CITY PLANNING COMMISSION AGENDA

FILE NO:
CPC MP 04-00280-A1MJ13 – LEGISLATIVE

PROJECT: DESIGN GUIDELINES FOR THE NORTH NEVADA AVENUE URBAN RENEWAL AREA

RE: Major Amendment to the North Nevada Avenue Urban Renewal Plan: Design Guidelines – File No.
CPC MP 04-00280-A1MJ13

Figure 6.4-B Example of Drive-Through Facility

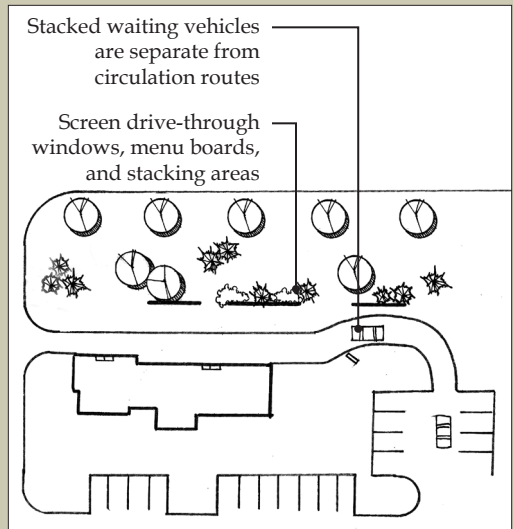
- f. Section 6.6. indicates gas canopies should not exceed 16’6” in height. Recently approved gas canopies have ranged in height from 18’ to 19’. Provide the height of the existing gas canopy for Costco. If necessary revise the recommended gas canopy height to match the height of the Costco gas canopy.
